**PLANNING COMMISSION STAFF REPORT
ADMINISTRATIVE ITEM**

**PLNPCM2011-00464
O'Reilly Auto Parts
Building and Site Design Review
1122 South State Street
November 9, 2011**

O'Reilly Auto Parts is requesting a building and site design approval at 1122 South State Street to allow them to build a new auto parts retail store that would not meet the minimum first floor glass requirement along one of its street frontages, Harvard Avenue, in the Corridor Commercial (CC) zoning district and South State Street Corridor (SSSC) overlay district. The Planning Commission has final decision making authority for building and site design review.

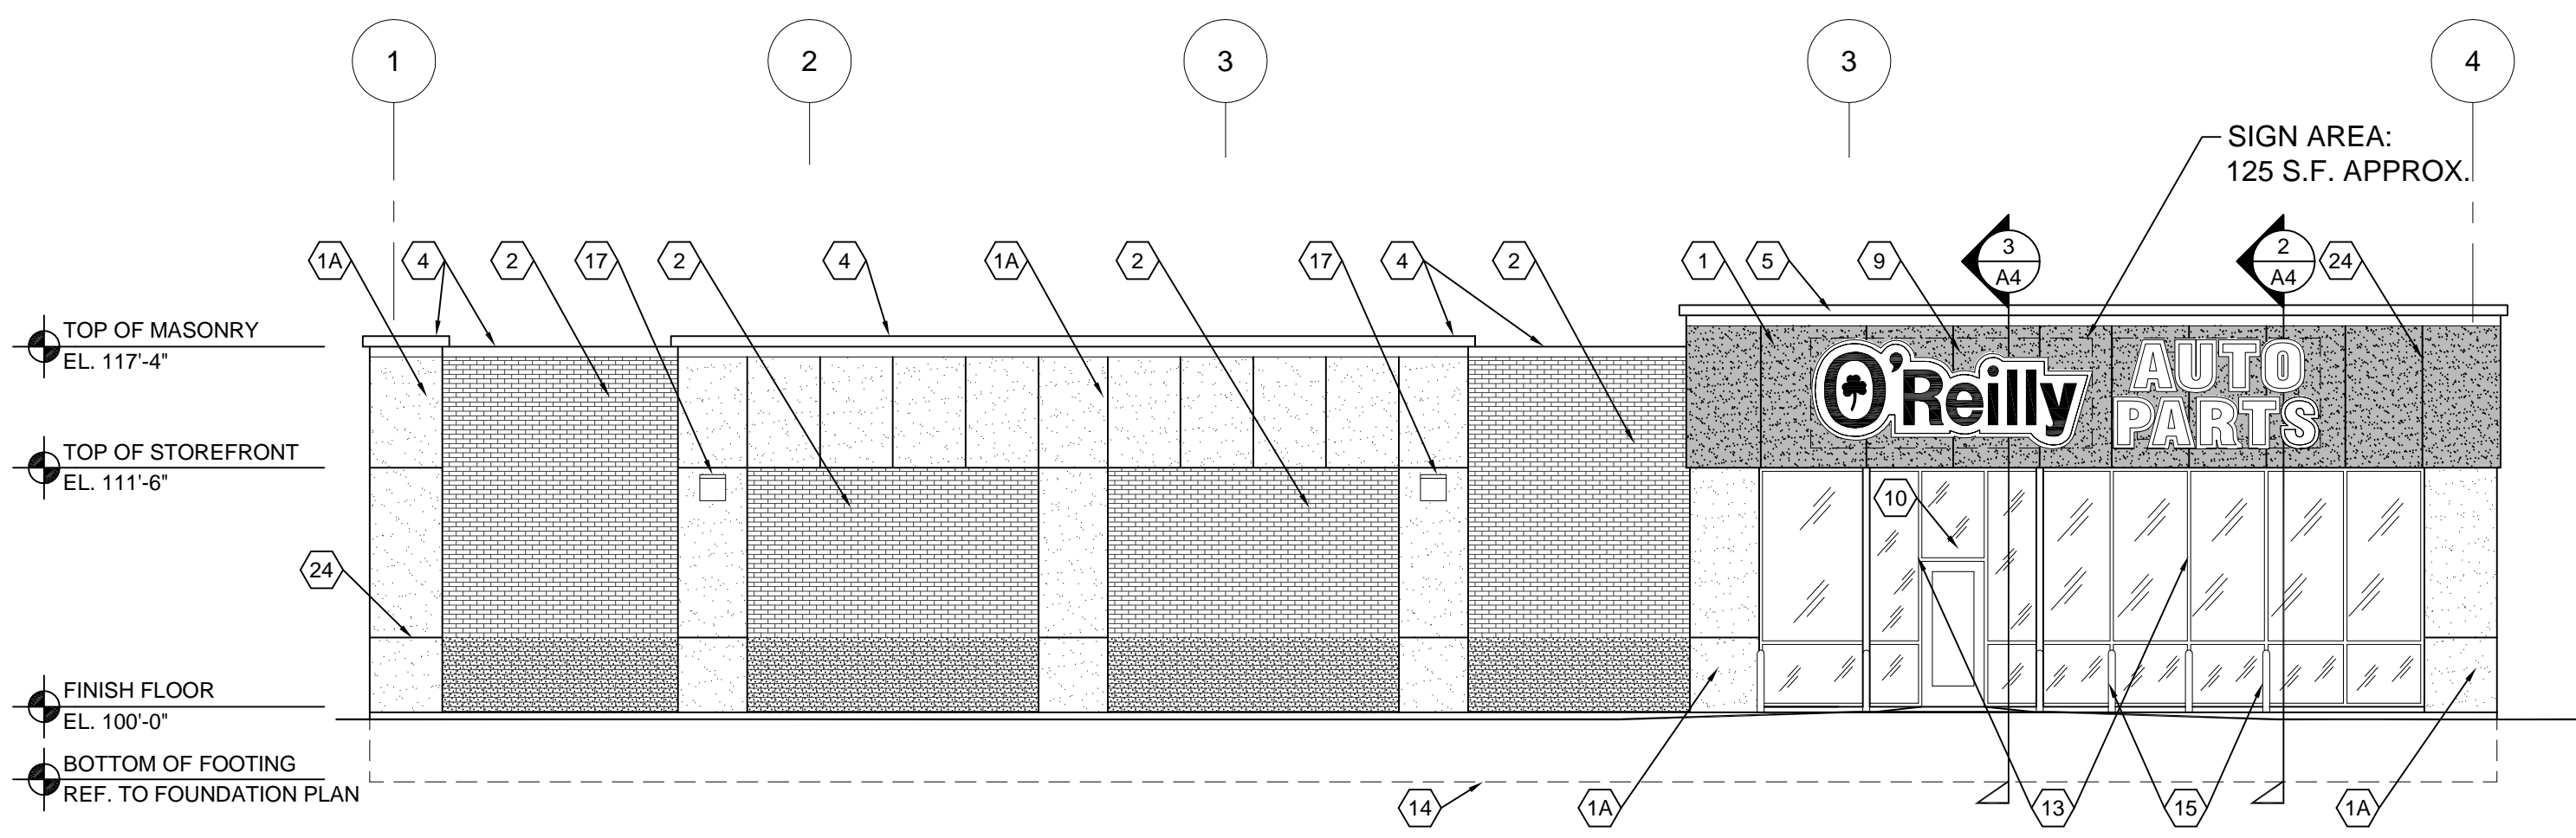
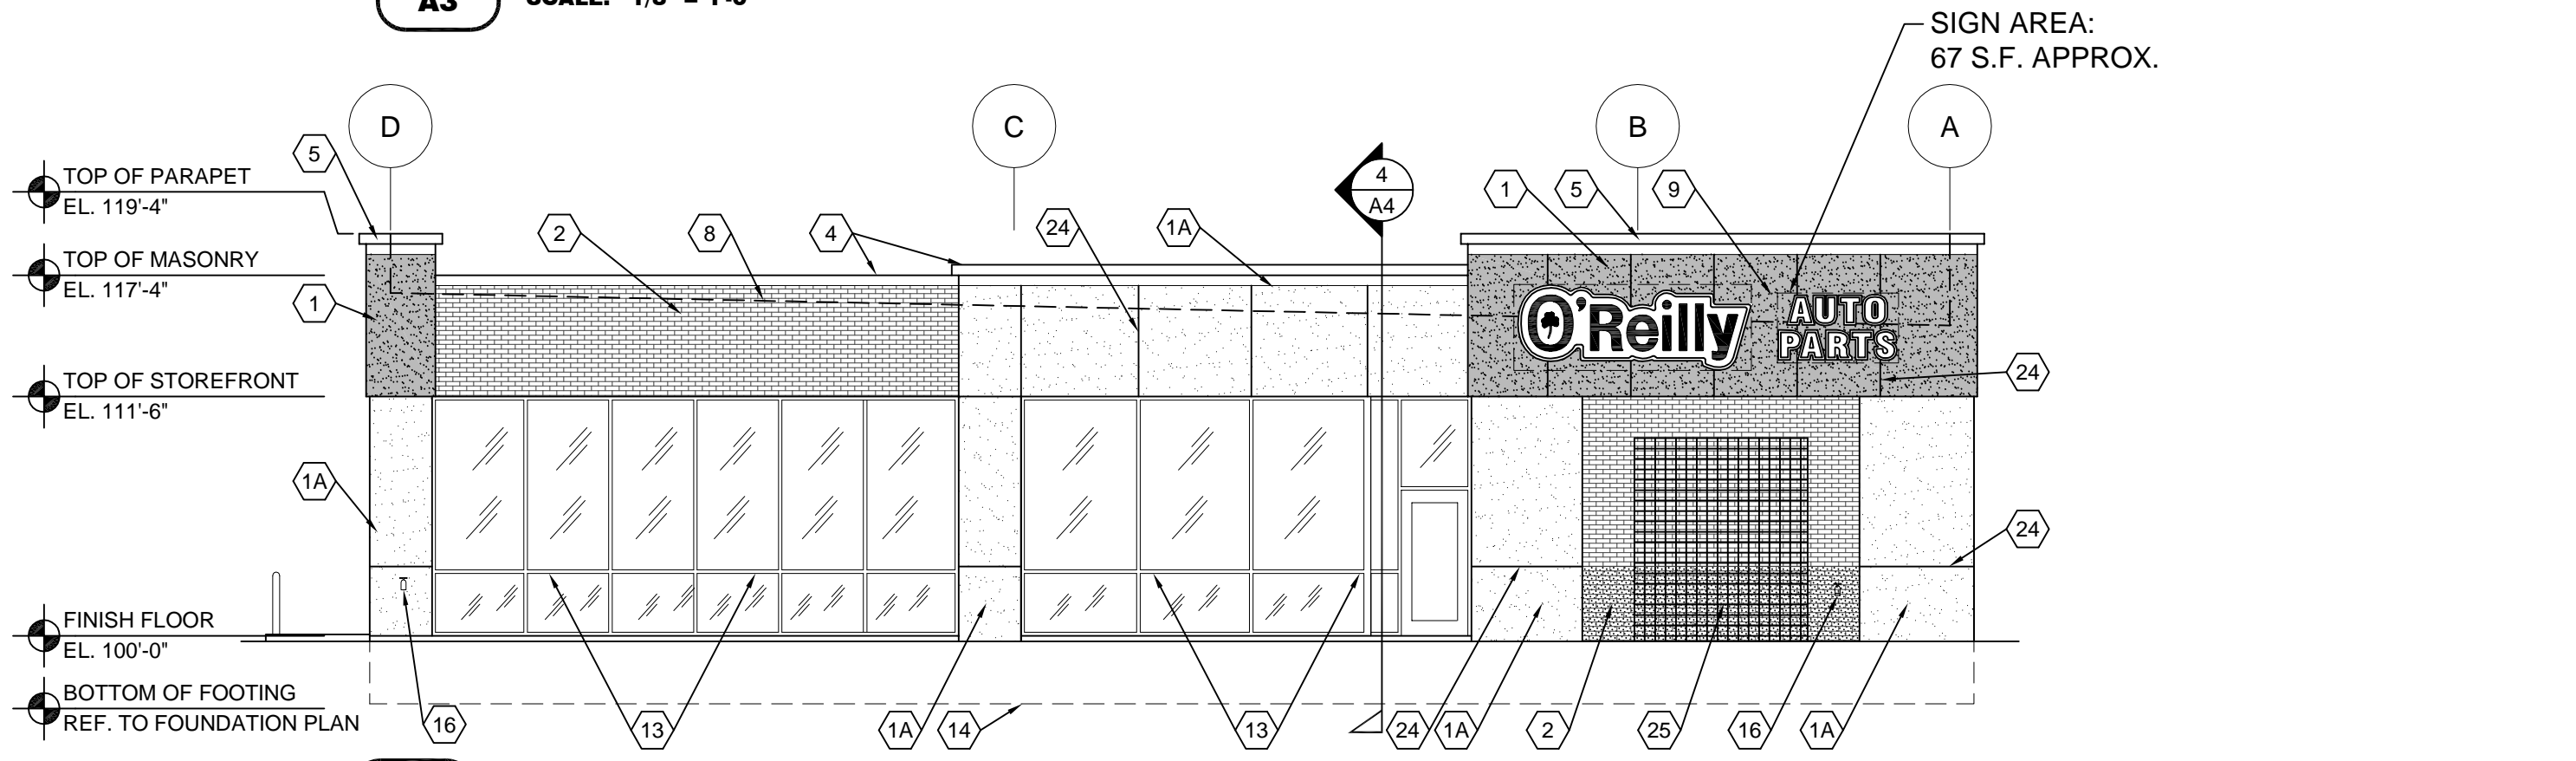
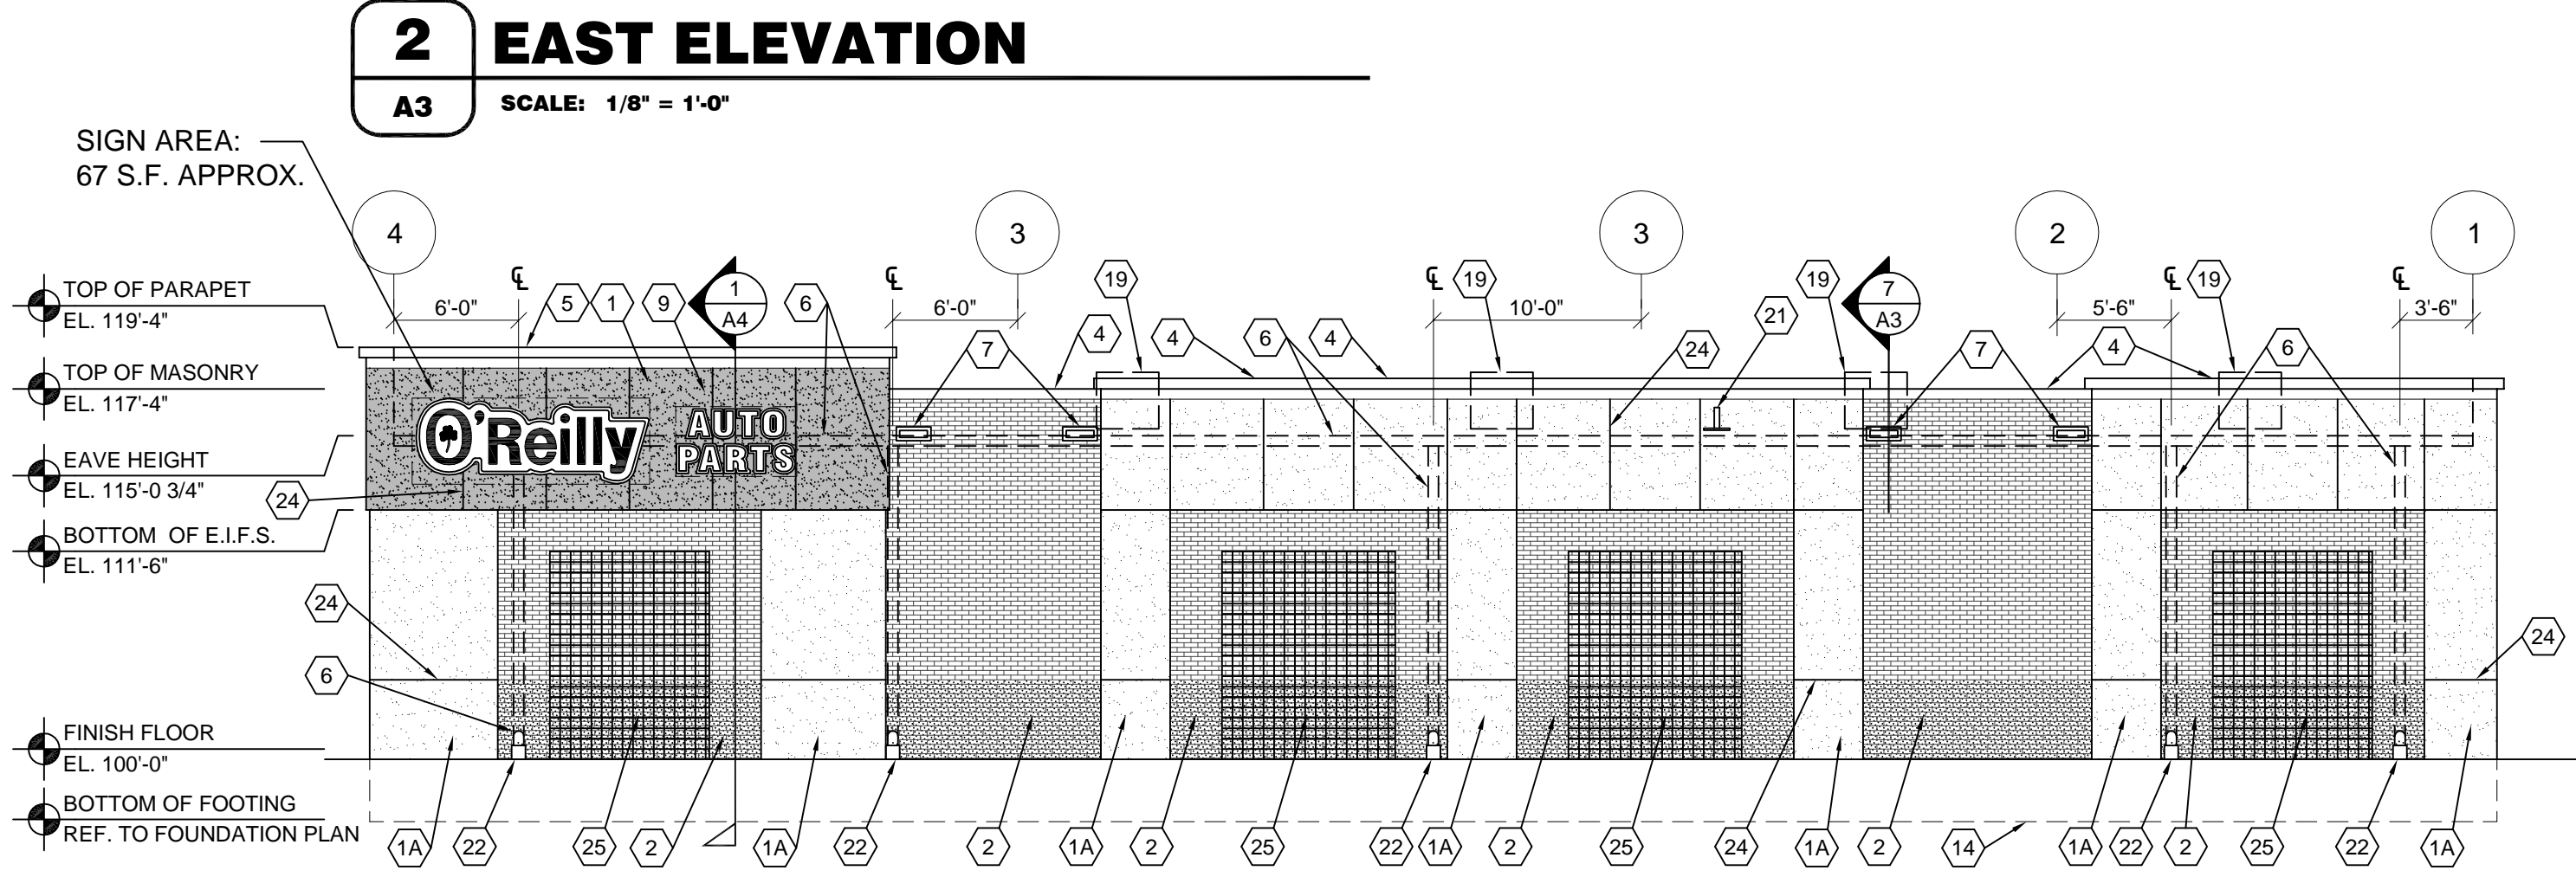
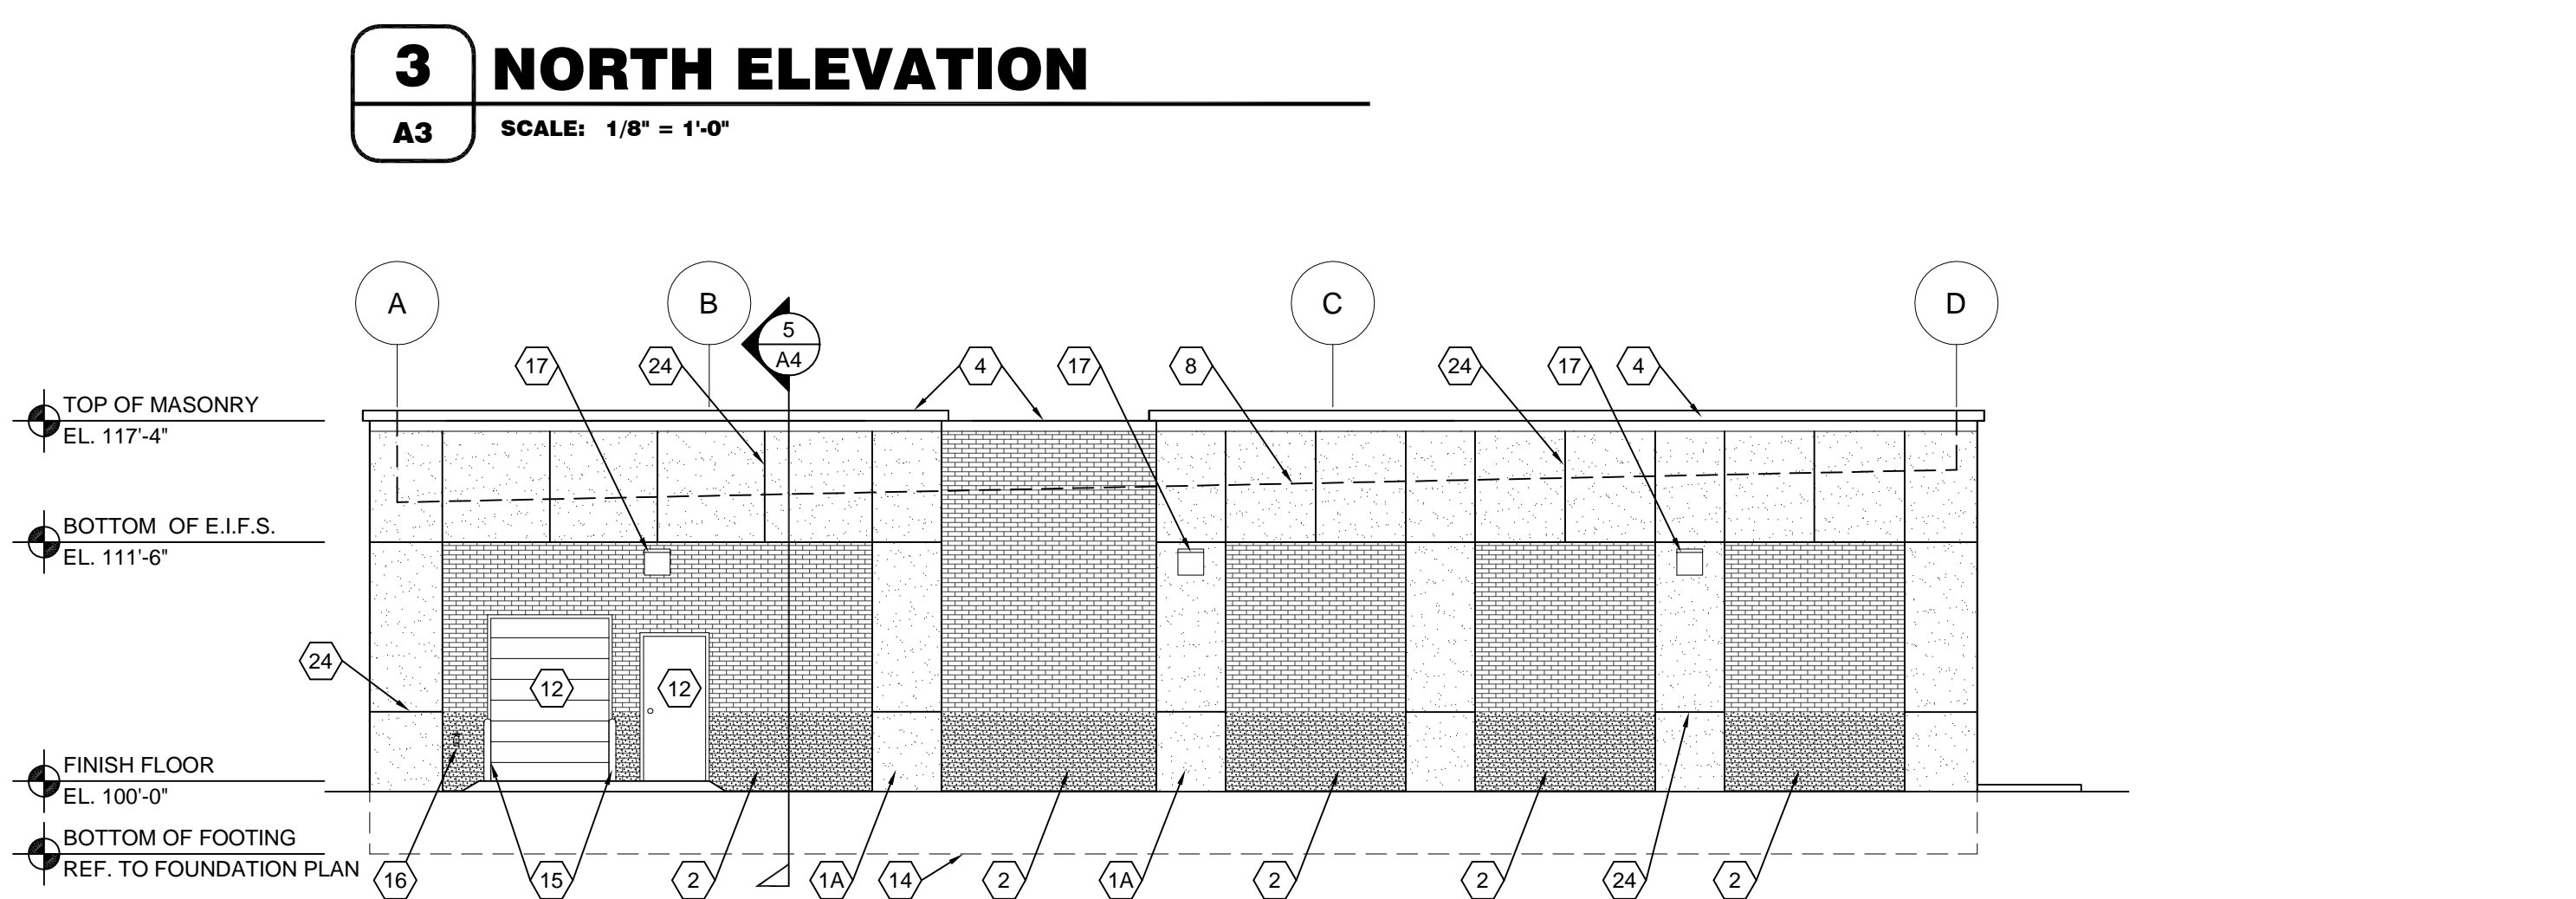
Analysis: The proposed building façade along State Street will be forty percent (40%) transparent glass. The façade facing the south parking lot will be twenty-one percent (21%) transparent glass. The building façade along Harvard Avenue will not have glass or doors, thus not meeting the requirement. The portion along Harvard Avenue will have a horizontal shift in the roof line and different types of building materials and plantings to break up the monolithic wall. The building only

Finding: Staff finds that the building only meets the criteria for the building façade along State Street. The building does not meet the standard for the façade along Harvard Avenue. This requirement is similar to the requirements of the South State Street Corridor (SSSC) overlay district in which the applicant is asking for relief. While the applicant does not meet the requirement, it does break up the store front along Harvard Avenue with a horizontal shift in the roof line and different types of building materials and plantings.
